UNITED STATES PATENT AND TRADEMARK OFFICE

| APPLICATION NO. | FILING DATE | FIRST NAMED INVENTOR | ATTORNEY DOCKET NO. | CONFIRMATION NO. |
|---|-------------|----------------------|---------------------|------------------|
| 10/714,935 | 11/18/2003 | Kazuhiro Maeda | 1035-483 | 3704 |

Office Action Summary

DETAILED ACTION

**Fig. 6**

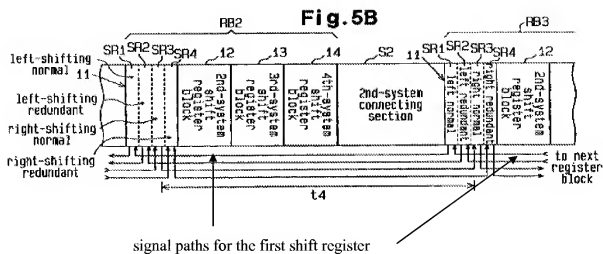
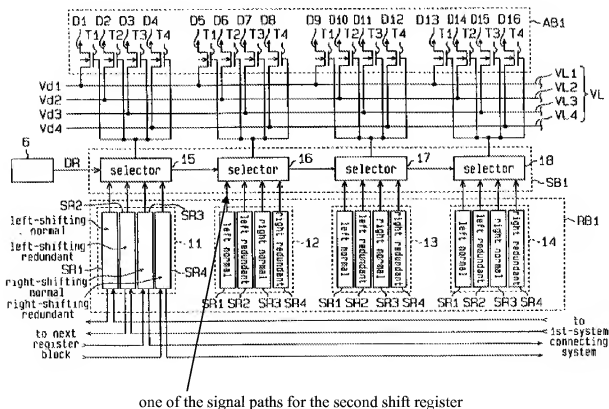
Regarding to the limitation, “signal paths for the first and second shift registers are provided separately for each of the first and second shift registers on respective sides of a circuit alignment of the first and second unit circuits of the first and second shift registers” (see lines 12-14 of claim 1), Kihara discloses that the signal paths (the paths connecting the left-shifting normal register SR1 to the next left-shifting normal register of the first shift register groups 11; see the below annotated Fig. 5B) for the first shift registers (left-shifting normal registers SR1 of the first shift register groups 11; Figs. 5A-5B, 6) are provided on the **bottom** of the circuit alignment of the unit circuits of the first and second shift registers (Fig. 5A, 5B) and the (output) signal paths for the second shift registers (left-shifting normal registers SR1 of the second shift register groups 12; see the below annotated Fig. 6) are provided on the **top** of a circuit alignment of the unit circuits of the first and second shift registers (see the below annotated Fig. 6).

As to claim 18, as discussed in the rejection to claim 17 above, Kihara teaches the other circuits or the second unit circuits (left-shifting normal registers SR1 of the second shift register groups 12; Figs. 5A-5B, 6) comprising circuits (Fig. 8), each including elements 90-92 and their connections and corresponding each of the claimed waveform processing circuits.

Regarding to the limitation, “signal paths for the first and second shift registers are provided separately for each of the first and second shift registers on respective sides of a circuit alignment of the first and second unit circuits of the first and second shift registers” of these claims, see the rejection to claim 1 above.

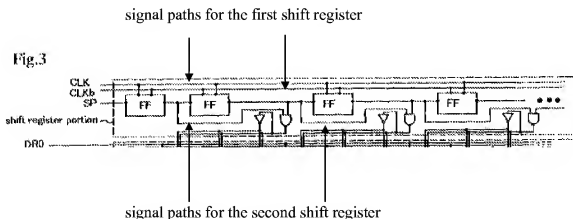
Azami teaches the first shift register comprising **4 first unit circuits** (4 FF circuits) spaced-apart cascade-connected; outputting an input signal (a start pulse SP; see Fig. 3) in response to a clock signal (CLK; see Fig. 3, col. 6, lines 64-67); and sequentially outputting a selection signal from output-stages comprised of the unit circuits (see Fig. 3, col. 6, lines 64-67). Azami further teaches the first unit circuits (FF circuits) of the first shift register being linearly disposed so that physical spaces are provided between adjacent pairs of the unit circuits (see Fig. 3).

Azami further teaches that **first circuits are the second unit circuits, (each circuit including an inverter, an NAND, and their connections;** see Fig. 3), are different from the first unit circuits (first 4 FFs) of the first shift register, are disposed in the physical spaces between adjacent first unit circuits (FFs), and have outputs, which are not supplied to any of the first unit circuits (FF circuits) of the first shift register (see Fig. 3).

Regarding to the limitation, “signal paths for the first and second shift registers are provided separately for each of the first and second shift registers on respective sides of a circuit alignment of the first and second unit circuits of the first and second shift registers” (see lines 12-14 of claim 1), Azami teaches the signal paths for the first shift register (paths for transmitting clock signals to each FF circuit of the first shift register; see the below annotated Fig. 3) provided on the **top side** of a circuit alignment of the unit circuits of the first and second shift registers and the signal paths for the second shift register (paths for transmitting the output signals from the inverters and NAND gates to the first latch portion; see the below annotated Fig. 3) provided on

the **bottom side** of a circuit alignment of the unit circuits of the first and second shift registers
(see the below annotated Fig. 3).

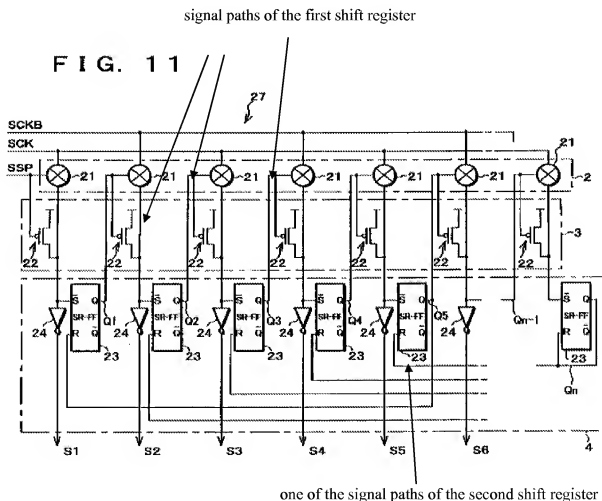
Regarding to the limitation, “signal paths for the first and second shift registers are provided separately for each of the first and second shift registers on respective sides of a circuit alignment of the first and second unit circuits of the first and second shift registers” (see lines 12-14 of claim 1), Washio teaches the **signal paths** for the first shift register (paths for transmitting set signals to Sbar terminals to the first four FFs 23 or output signals Q from the first four FFs 23; see the below annotated Fig. 11) provided on the **top side** of a circuit alignment of the unit

circuits of the first and second shift registers and **signal paths** for the second shift register (paths for transmitting the reset signals R to the R terminal of the next 4 FFs of the second shift register; see the below annotated Fig. 11) provided on the **bottom side** of a circuit alignment of the unit circuits of the first and second shift registers (see the below annotated Fig. 11).

As to claim 3 and 18, as discussed above, the first circuit (24) (e.g., **the second inverter 24** shown in Fig. 11) is considered as a processing circuit (of claim 3) or a waveform processing circuit (of claim 18) (see Fig. 11).
